Network Video Recorder
Version: V5.05.381 build260714
Release Note

Firmware Basic Information	Firmware Version:	V5.05.381_build260714
	SDK Version:	6.1.9.48
	Play Library:	6.0.1.52
	Web component:	V5.1.69_R0102 build 260615
	OpenSDK Version:	2.15.3 (Ezviz), 2.14.1 (OTAP)

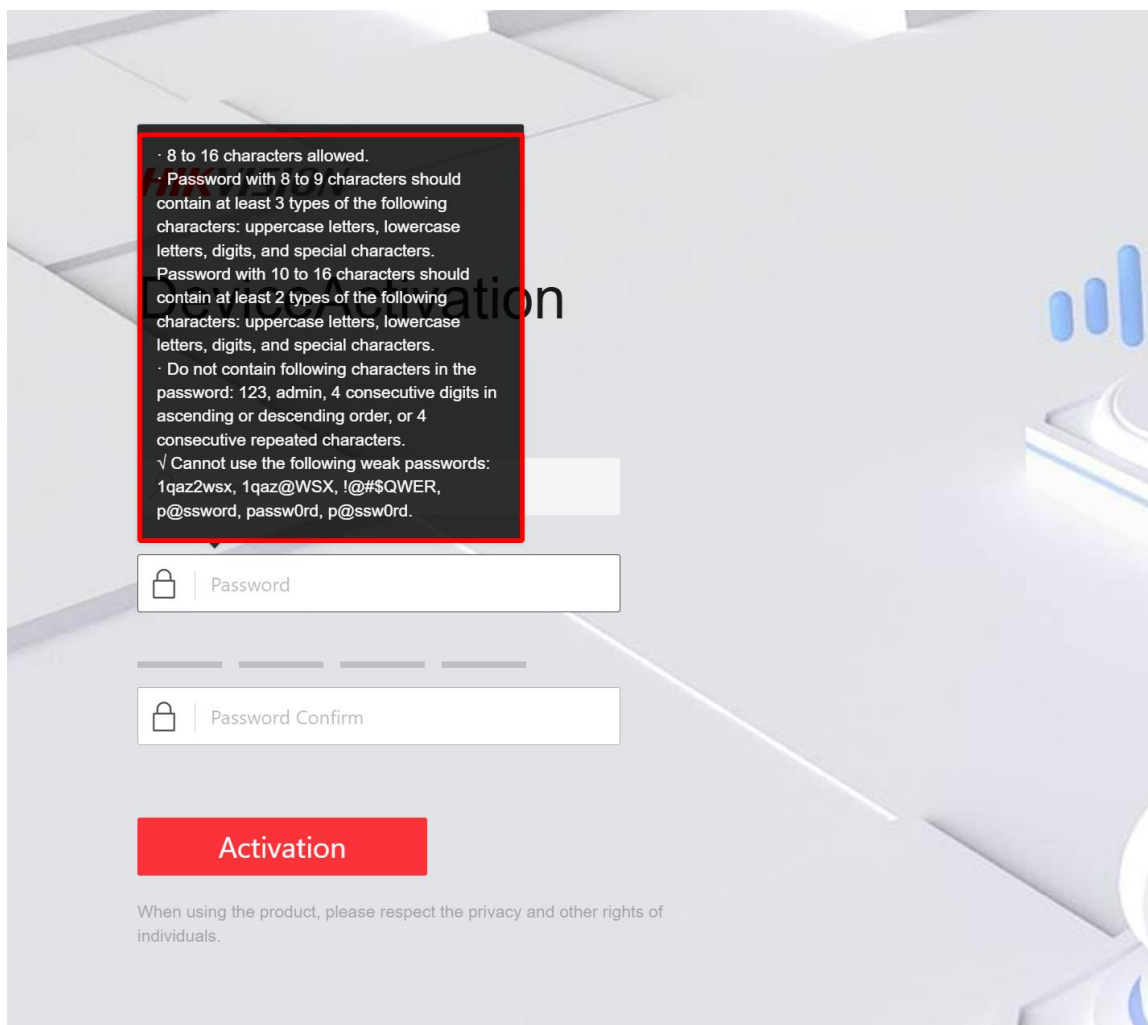
1. Before the device is activated, after the region is selected as the Korean region, the password input scenarios for local and remote device activation, password reset, user password setting, channel default password, and camera activation settings must meet one of the following password requirements (the following restrictions are added on the basis of the original password settings, choose one of the two options):

- Composed of three of the following: uppercase letters, lowercase letters, numbers, special characters, and the length must be no less than 8 characters.
- Composed of a combination of 2 types of uppercase letters, lowercase letters, numbers, and special characters, and the length must be no less than 10 characters.

2. Adjustment of input interface prompts, the original requirements for length and characters are changed to the following description, everything else remains the same:

- 8 to 16 characters allowed
- Password with 8 to 9 characters should contain at least 3 types of the following characters: uppercase letters, lowercase letters, digits, and special characters.
- Password with 10 to 16 characters should contain at least 2 types of the following characters: uppercase letters, lowercase letters, digits, and special characters
